ADDENDUM C

NORTH PARK MINI PARK

BID NO.:	<u>K-20-1864-DBB-3</u>
SAP NO. (WBS/IO/CC):	<u>S-10050</u>
CLIENT DEPARTMENT:	<u>1714</u>
COUNCIL DISTRICT:	<u>3</u>
PROJECT TYPE:	<u>GC</u>

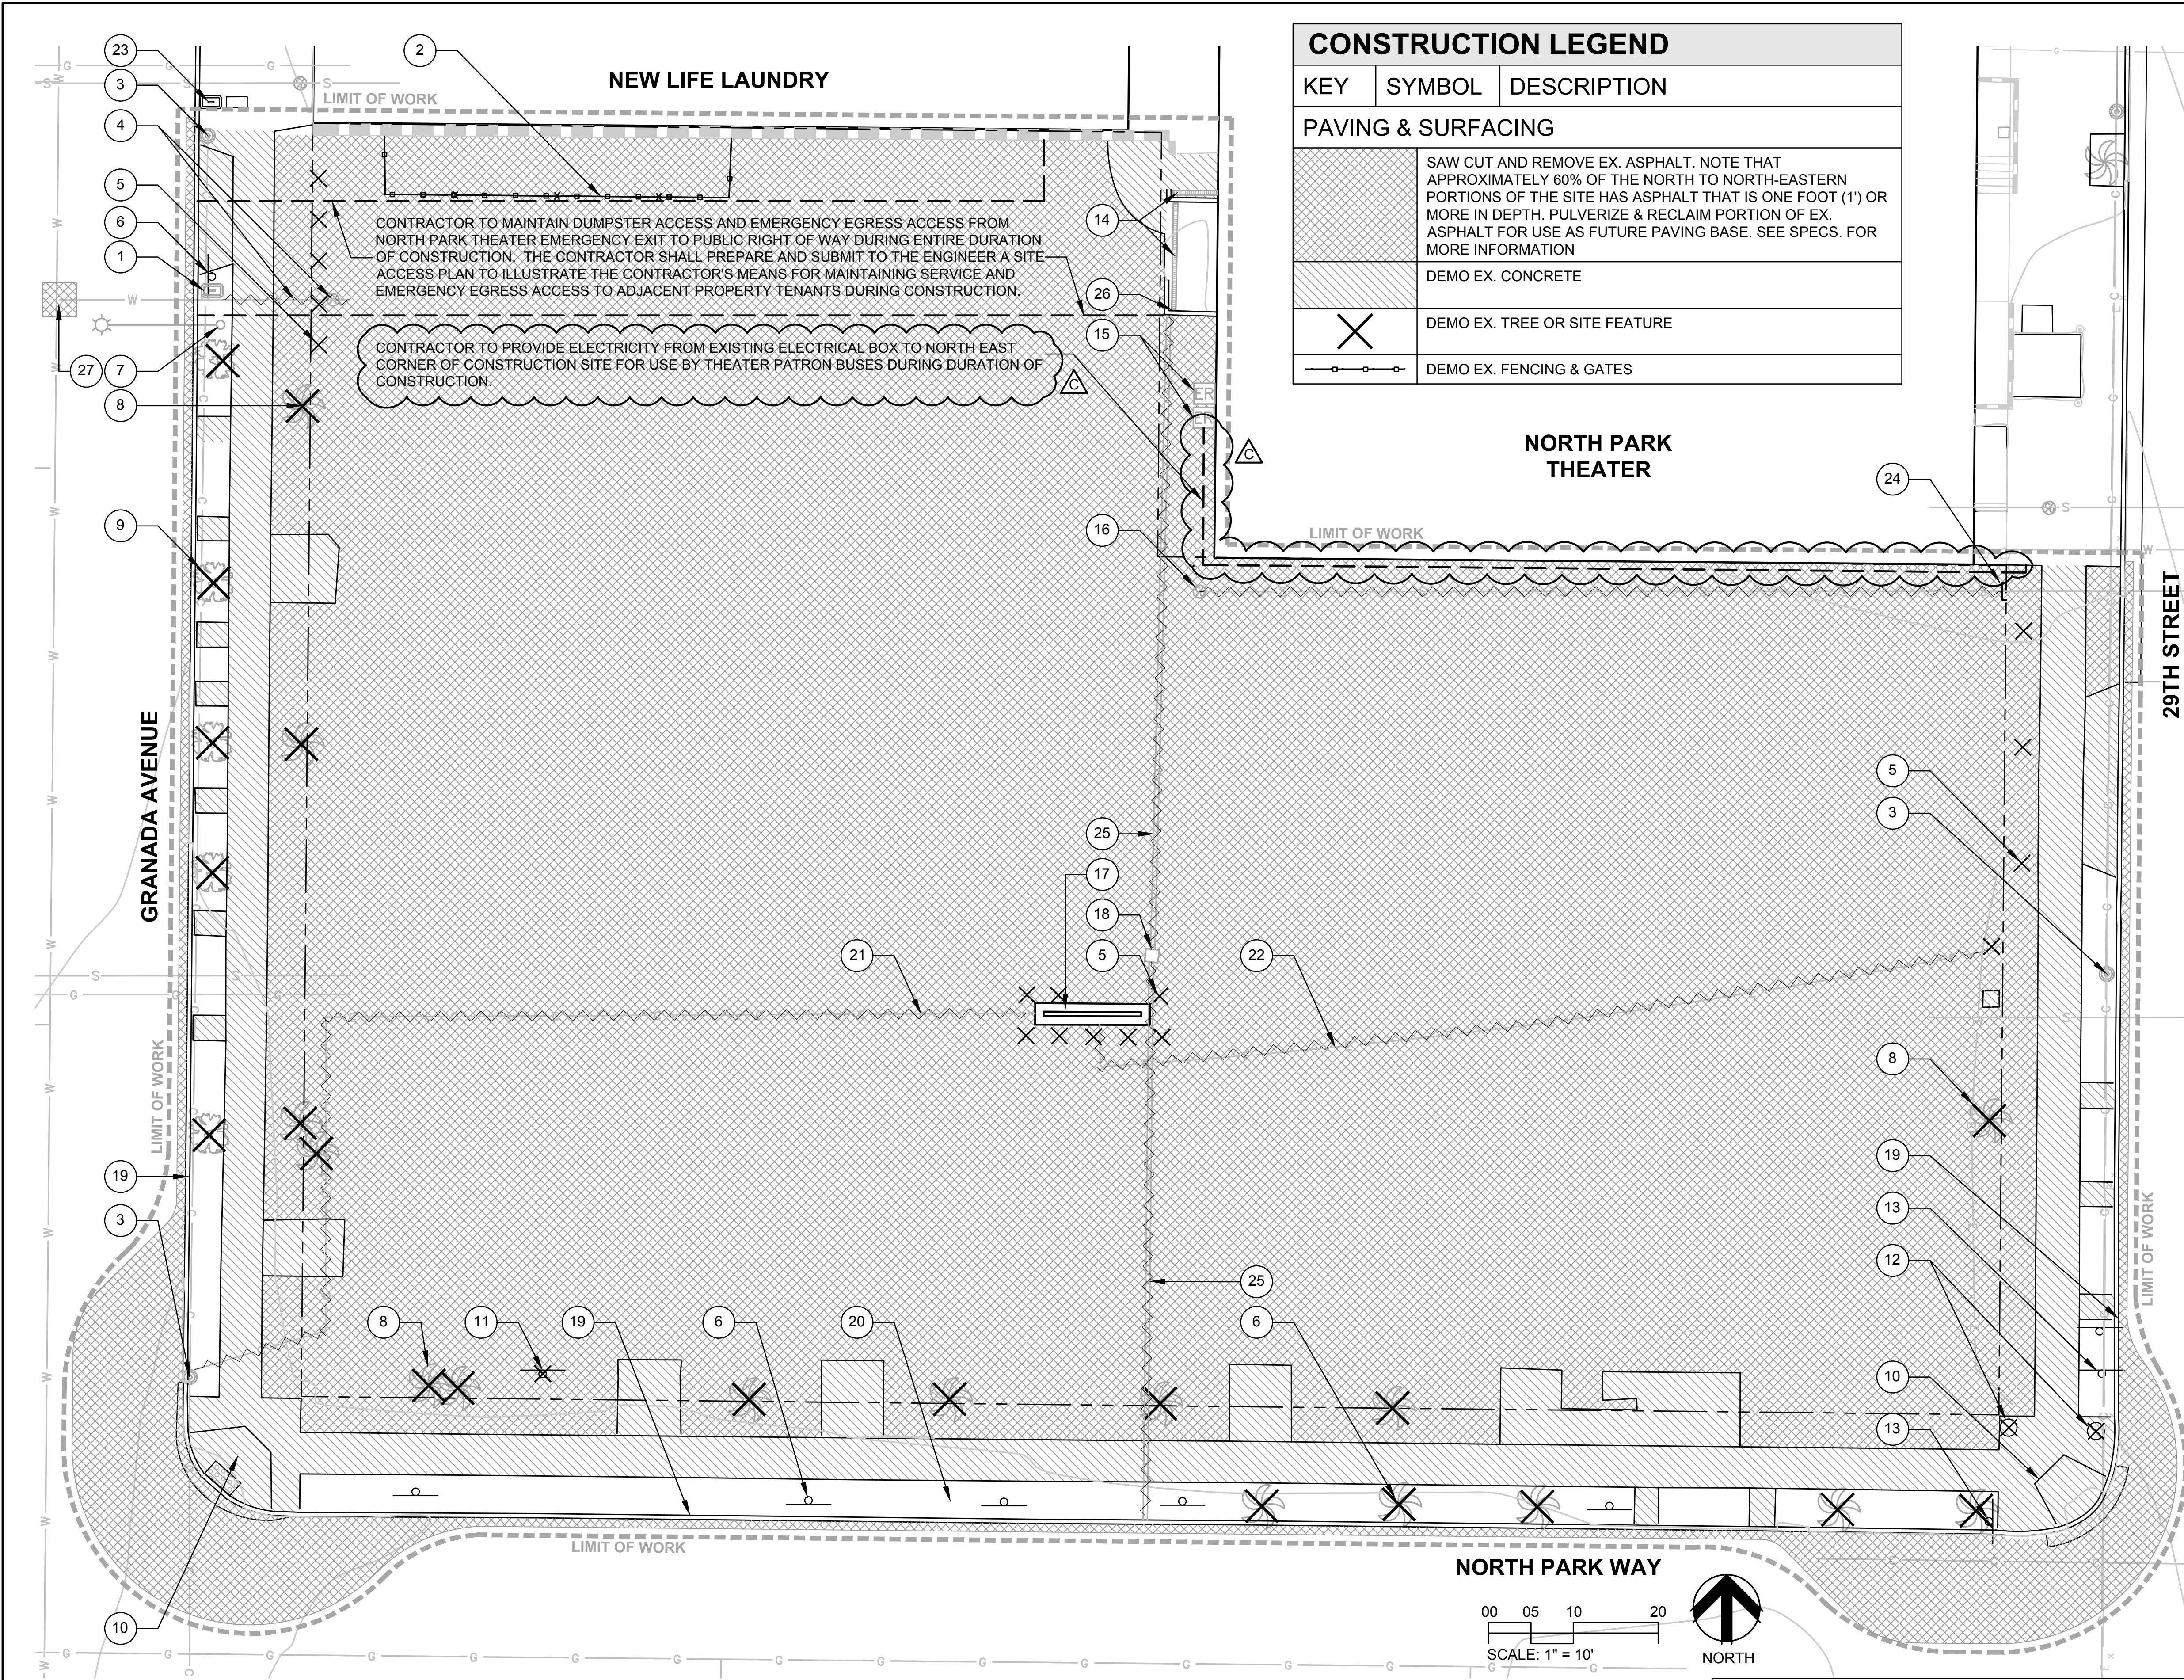
CHANGES TO NOTES. ADDITION OF FAA NOTES.

PLANS FOR THE CONSTRUCTION OF:
NORTH PARK MINI PARK
GRADING PLAN

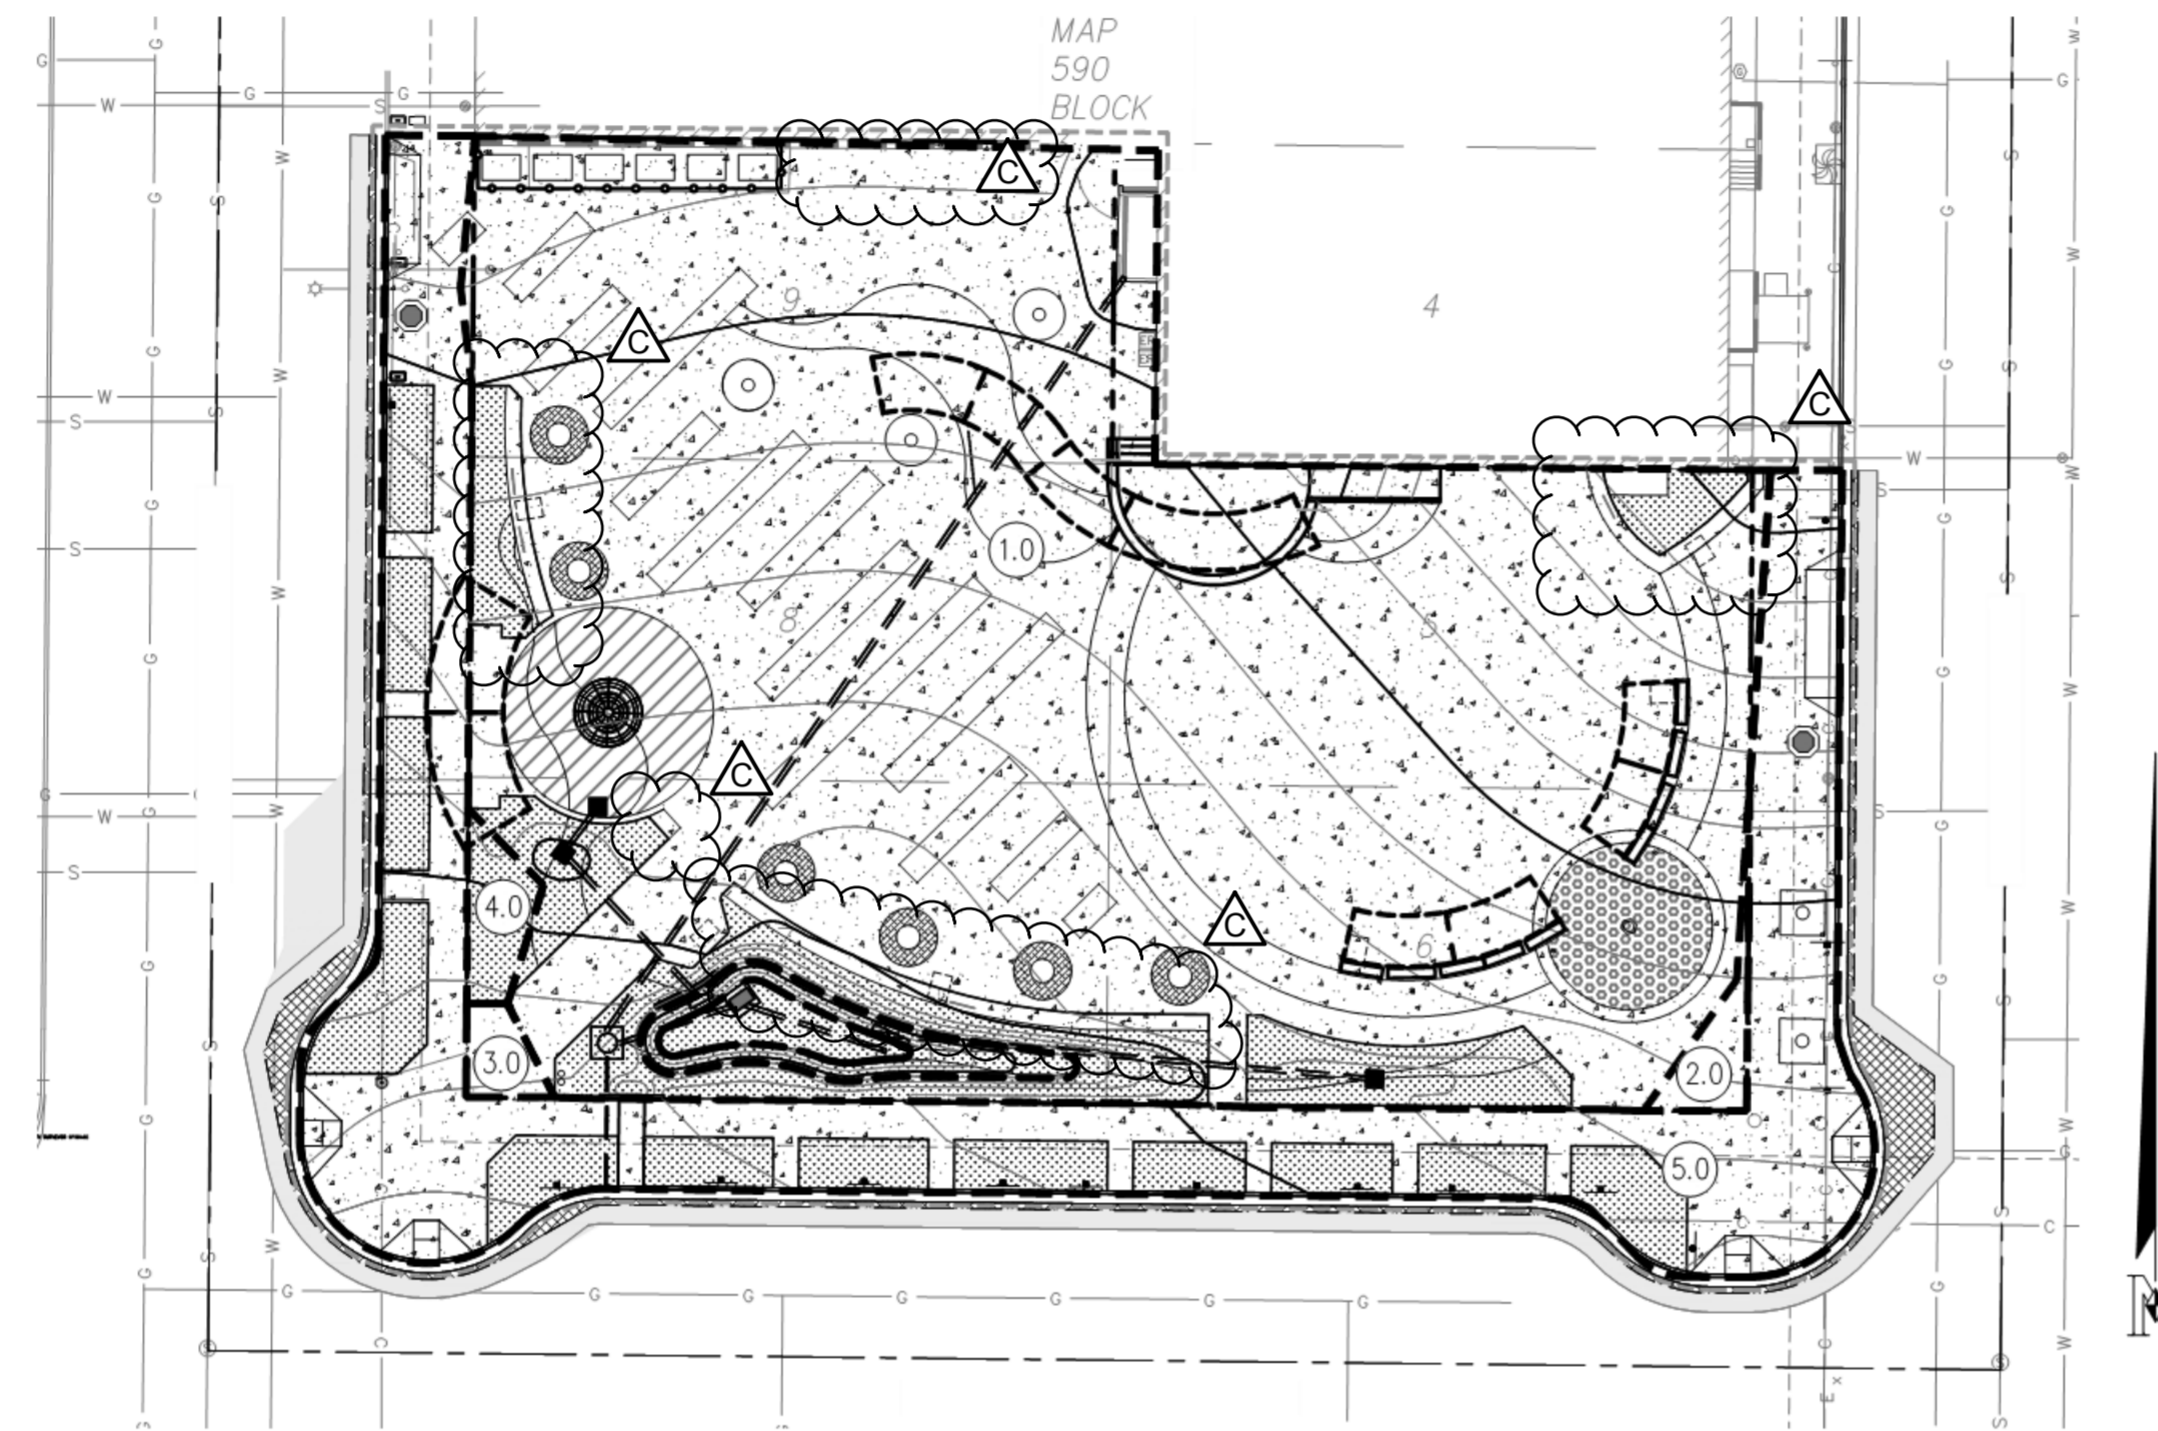
CHANGES TO PLAN, DG CHANGED TO CONCRETE. STORAGE CONTAINERS REMOVED.

NORTH PARK MINI PARK
NORTH PARK WAY IMPROVEMENT PLAN

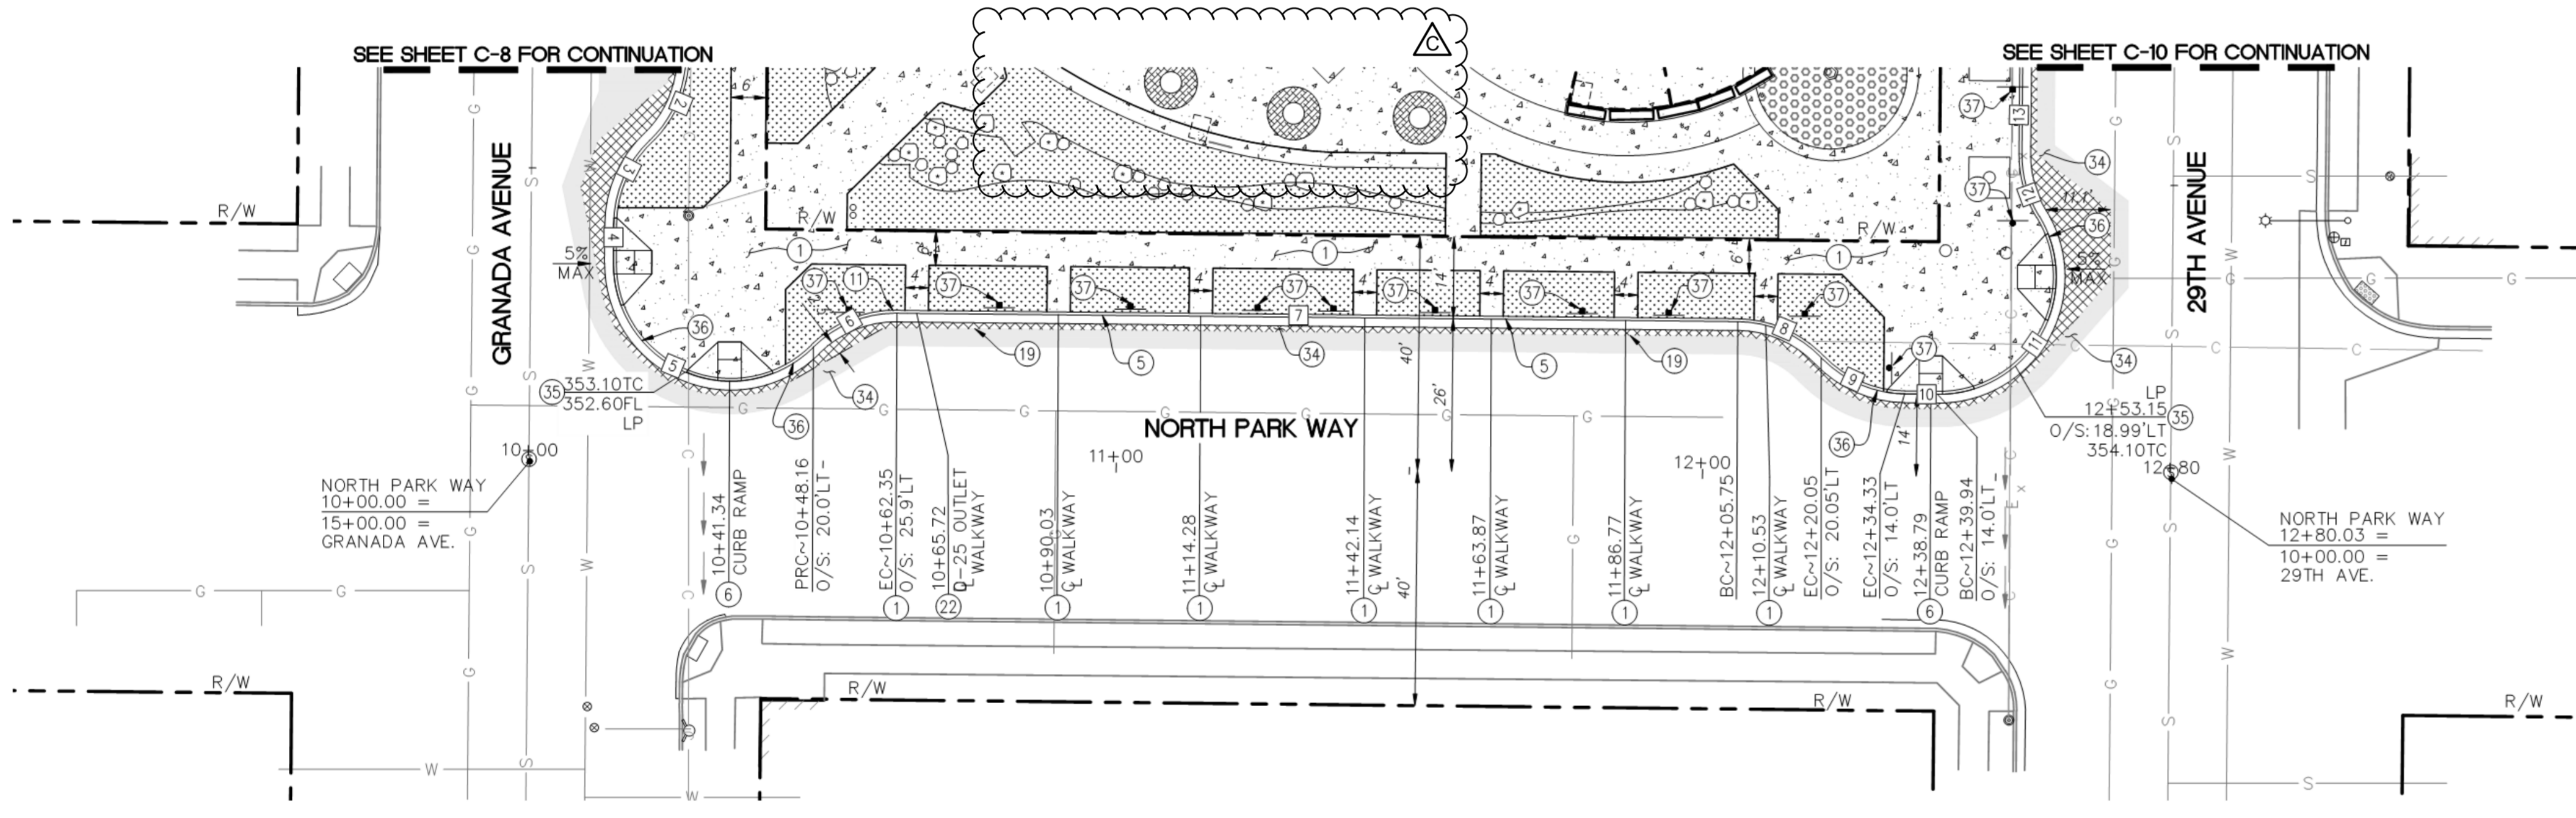
CHANGES TO PLAN: DG CHANGED TO CONCRETE. STORAGE CONTAINERS REMOVED.
